ORDINANCE NO. 936

**AN ORDINANCE AMENDING SECTION 18-3001
ADOPTION – BUILDING CODE**

EXHIBIT “A”

**Amendments to International Building Code,
2009 Edition**

FIGURE R404.1.2(9)

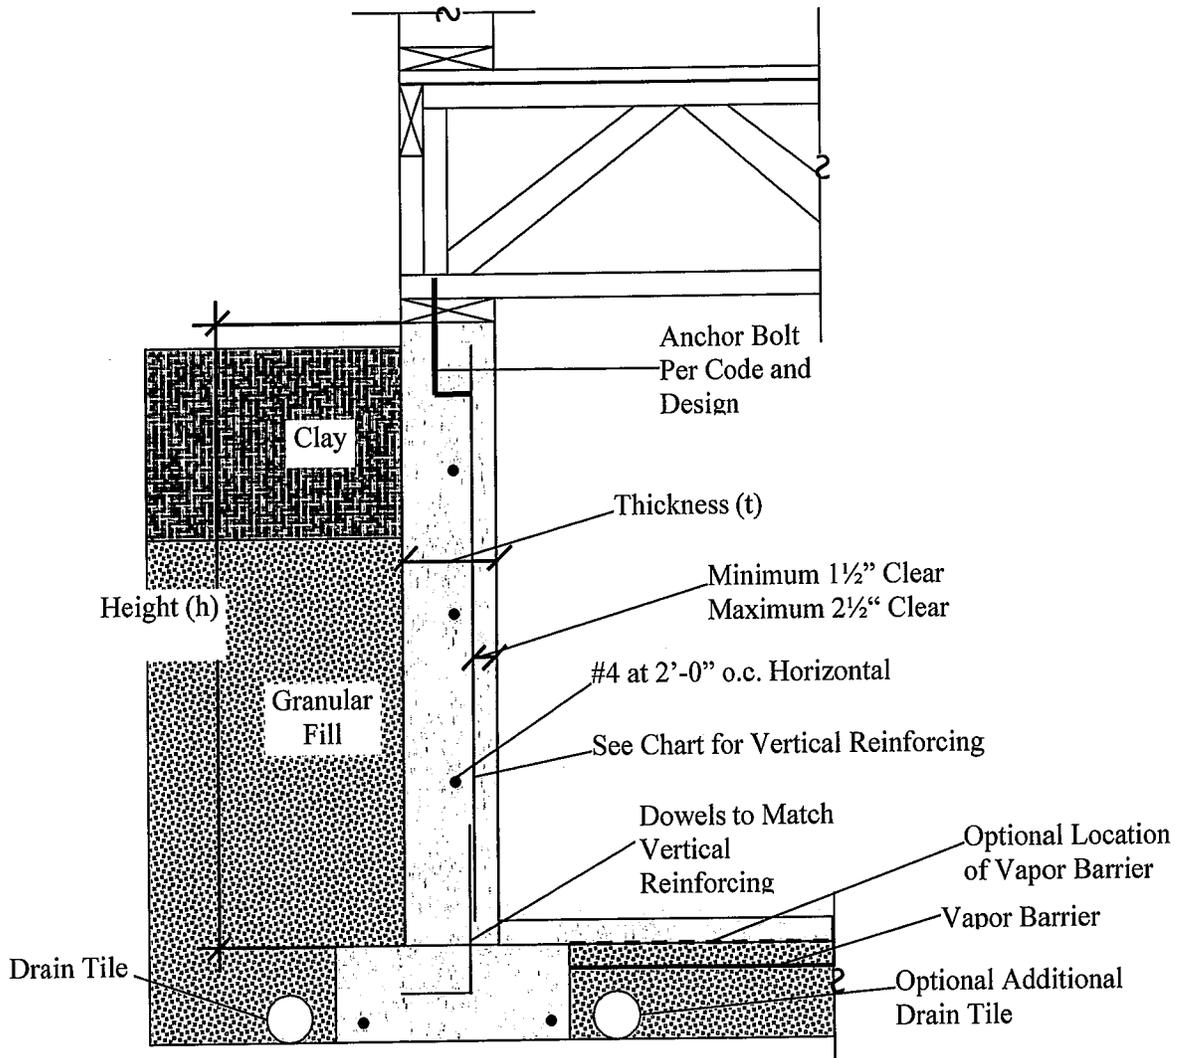
Table R404.1.2(9) is added as follows:

Table R404.1.2(9)
Foundation Wall Reinforcing

1. Chart is based on an active soil pressure of 65 pounds per cubic foot (pcf).
2. Reinforcing steel shall be ASTM A615 Fy – 60,000 pounds per square inch (psi).
3. The vertical reinforcing bars are to be located on the inside face.
4. Minimum concrete strength $F_c^1 = 3,000$ pounds per square inch (psi).
5. Backfill shall not be placed until first floor framing and sheathing is installed and fastened or adequately braced and the concrete floor slab is in place or the wall is adequately braced.

FIGURE R404.1.2(10)

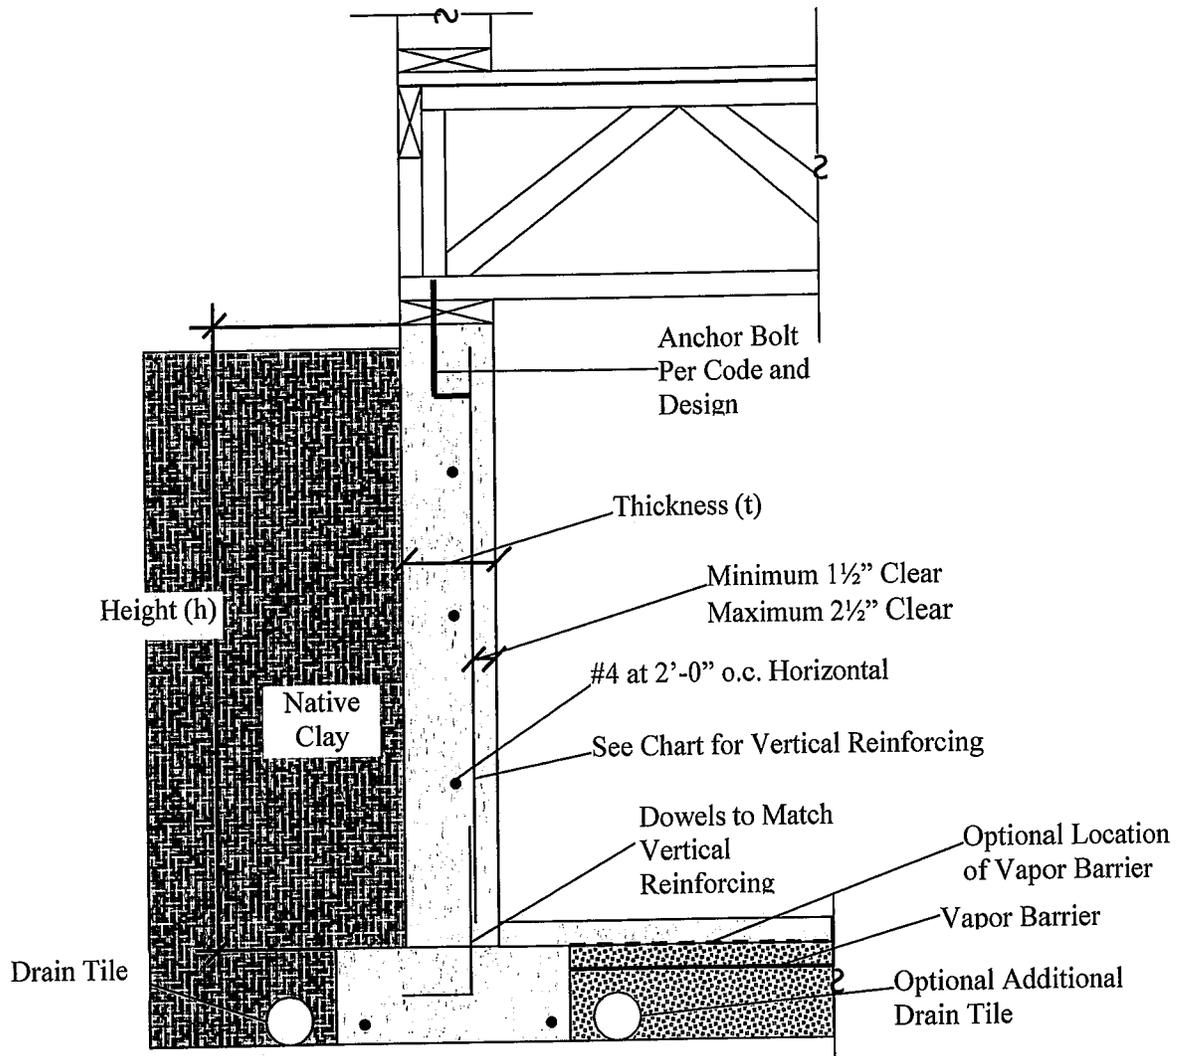
Table R404.1.2(10) is added as follows:

Table R404.1.2(10)
Foundation Wall Reinforcing

Active Pressure = 45pcf

Minimum Reinforcement for Concrete Foundation Walls		
Wall Height (h) feet	Wall Thickness (t) inches	Vertical Reinforcing
8	8	#4 @ 24" o.c. #5 @ 40" o.c.
	10	#4 @ 30" o.c. #5 @ 50" o.c.
9	8	#4 @ 18" o.c. #5 @ 28" o.c.
	10	#4 @ 24" o.c. #5 @ 36" o.c.
10	10	#4 @ 16" o.c. #5 @ 26" o.c.

Figure 304.6.2 is hereby amended as shown below:

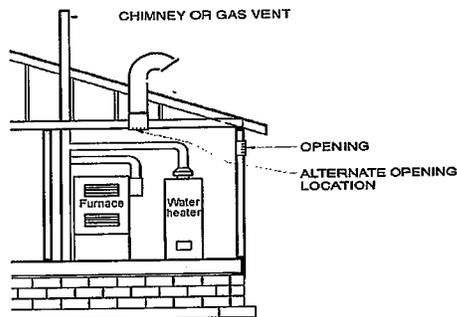
Section 304.6.2 is hereby amended to read as follows:

Section 304.6.2 One-permanent-opening method. One permanent opening, commencing within 12 inches (305 mm) of the top of the enclosure, shall be provided. The *appliance* shall have clearances of at least 1 inch (25 mm) from the sides and back and 6 inches (152 mm) from the front of the *appliance*. The opening shall directly communicate with the outdoors or through a vertical or horizontal duct to the outdoors, ~~or spaces that freely communicate with the outdoors (see Figure 304.6.2)~~ and shall have a minimum free area of 1 square inch per 3,000 Btu/h (734mm²/kW) of the total input rating of all appliances located in the enclosure and not less than the sum of the areas of all vent connectors in the space.
